## POWER TRIM RELAY - 135 thru 200

#### MARINER AND MERCURY

1995 1/2 and 1996 135-200 HP Models

Serial Number 0G201875 thru 0G335889

a - Relay (2)  
b - Harness

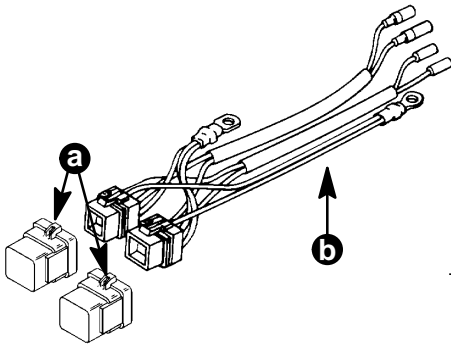
Beginning with Serial Number 0G201875 all 135-200 HP models utilize electronic relays to activate the power trim. During production assembly a dielectric compound was applied to the relay/harness connection. Under certain extreme conditions this dielectric compound can enter the relay causing an open circuit. This will not allow the power trim to operate. Testing has revealed that the relay does not require dielectric compound be installed for proper operation or sealing. Beginning with Serial Number 0G335890 the dielectric compound has been eliminated.

Remove both power trim relays and the power trim wire harness and install two (2) power trim relays p/n 828151 and one (1) power trim harness p/n 84-826802A 4. **DO NOT USE ANY DIELECTRIC COMPOUND OR SEALANT OF ANY KIND DURING REASSEMBLY.**
